## Application for Works Approval

<b>Works Approval Number</b>	W6718/2022/1
<b>Applicant</b>	Focus Operations Pty Ltd
<b>ACN</b>	115 821 255
<b>File number</b>	DER2022/000323
<b>Premises</b>	Three Mile Hill Gold Project COOLGARDIE WA 6429 Legal description -  Mining tenement M15/645 As defined by the premises map and coordinates attached to the issued works approval
<b>Date of report</b>	2 December 2022
<b>Proposed Decision</b>	Intent to grant works approval

**Figure 3: Site of proposed works**

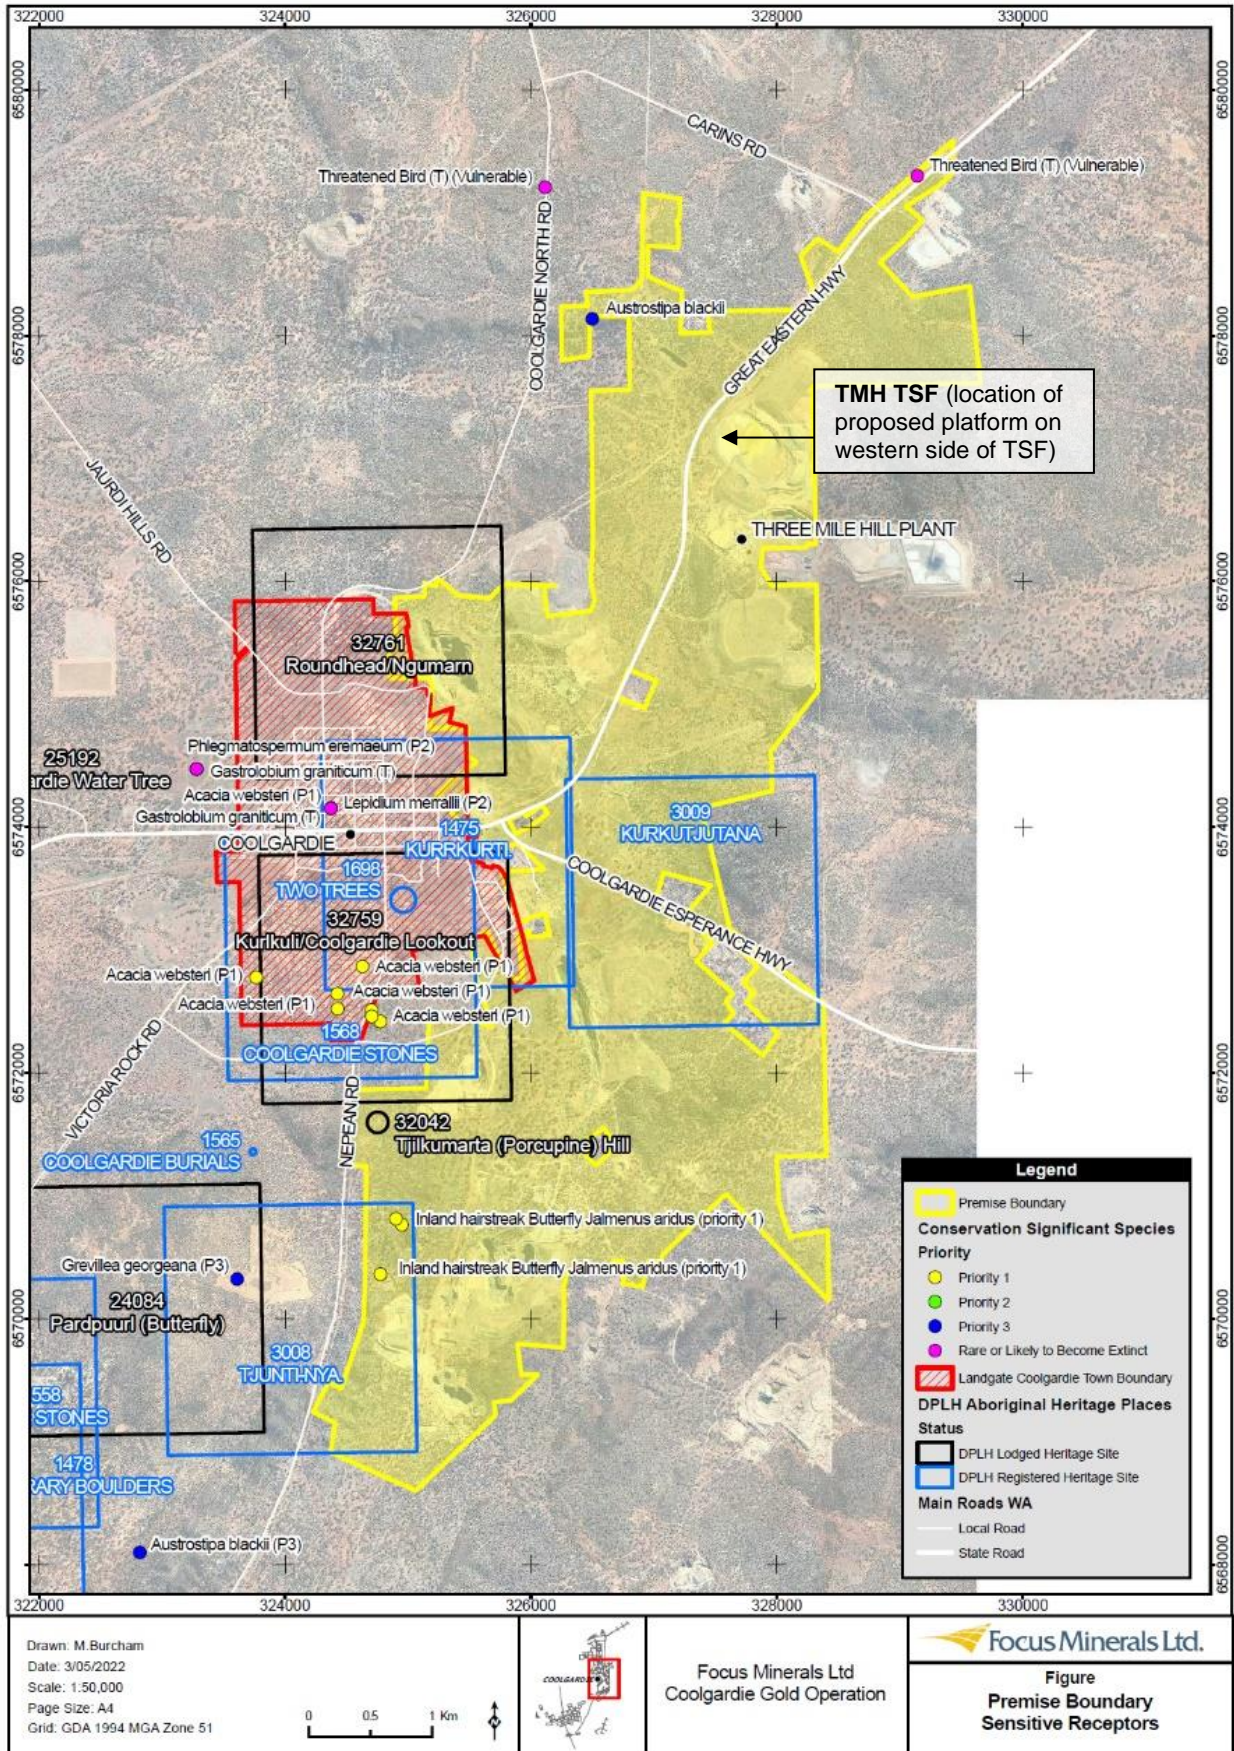
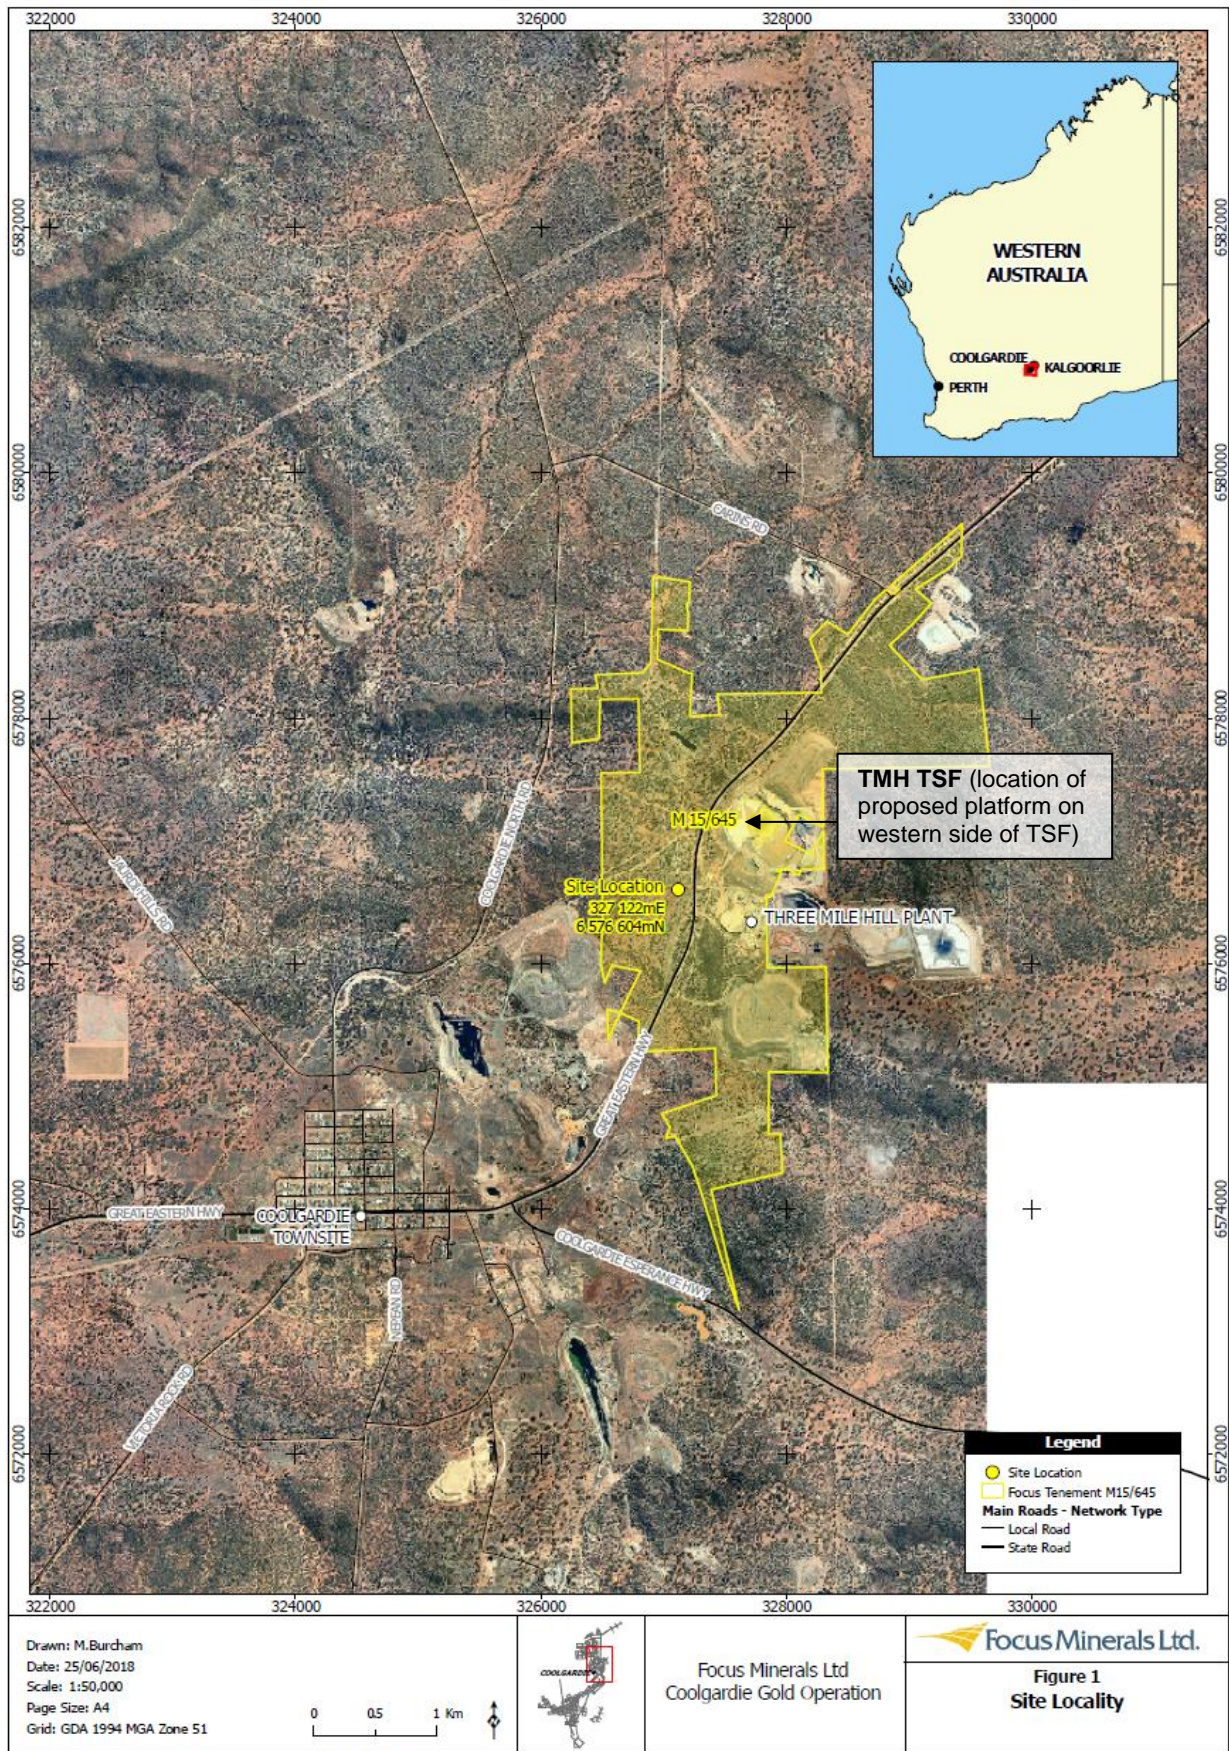
Department comment / condition	Summary of applicant's comment	Department's response
<b>Comment 1</b> – APPLICANT TO SPECIFY APPROPRIATE FINAL EXPECTED PERMEABILITY OF PLATFORM	The permeability is expected to be kv. Sat = 1 which is $1 \times 10^{-3}$ m/s.	Accepted and updated. The Department notes that this permeability matches up with material hydraulic properties assumed in the seepage model for the proposed stage 3 lift which was approved by DMIRS.
<b>Comment 2</b> - APPLICANT TO SPECIFY CREST WIDTH.	We are proposing a width of 0.5m	Accepted and updated.
<b>Comment 3</b> - APPLICANT TO CONFIRM IF ANY ADDITIONAL STORMWATER CONTROLS TO BE IMPLEMENTED WHICH SPECIFICALLY APPLY TO THE CONSTRUCTION OF THE PLATFORM AND NOT STAGE 3 LIFT WORKS	No as the platform will be incorporated into the existing TSF and then the Stage 3 raise.	Noted.
<b>Comment 4</b> - APPLICANT TO PROVIDE AN UPDATED PREMISES MAP/S CLEARLY DEPICTING THE PREMISES BOUNDARY WITH A PINK LINE, AS WELL AS THE LOCATION OF THE 1M BUNDS AROUND THE TMH TSF AND EROSION PROTECTION FEATURES. MAP TO INCLUDE NORTH ARROW, SCALE AND KEY.	Updated figure provided.	Accepted and updated.
